FCC Class II Permissive Change Application Letter

Equipment Product Code: [-10019A](#)

FCCID Number and Date of Original Grant: [A4C-10019A, 12/19/2025](#)

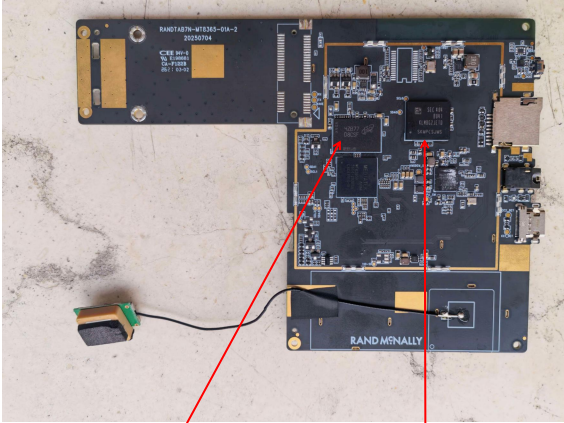
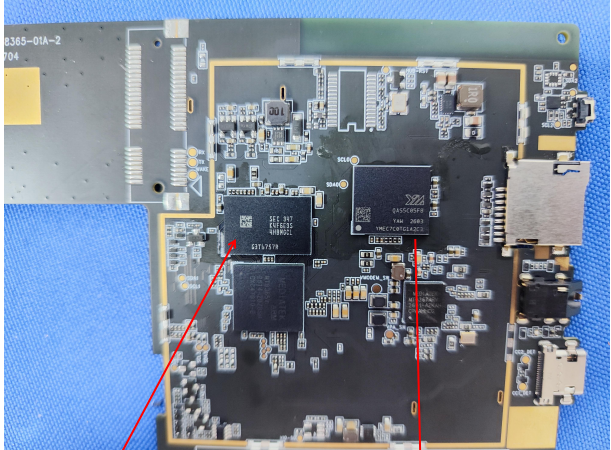
Original	New
1.Changed the product model number.	
RandTab8N	RandOneTab8
2.The software version has been changed	
TP1A.220624.014.RandTab7_mp_250606_29	RandOneTab8-userdebug 13 TP1A.220624.014 RandOneTab8_mp_260818_10 diag
3.eMMC chip and DDR chip model replacement

DDR:MT53E512M32D1NP-046WTB

EMMC:KLMBG2JETD-B041

DDR:K4F6E3S4HB-MGCL

EMMC:YMEC7COTG1A2C3
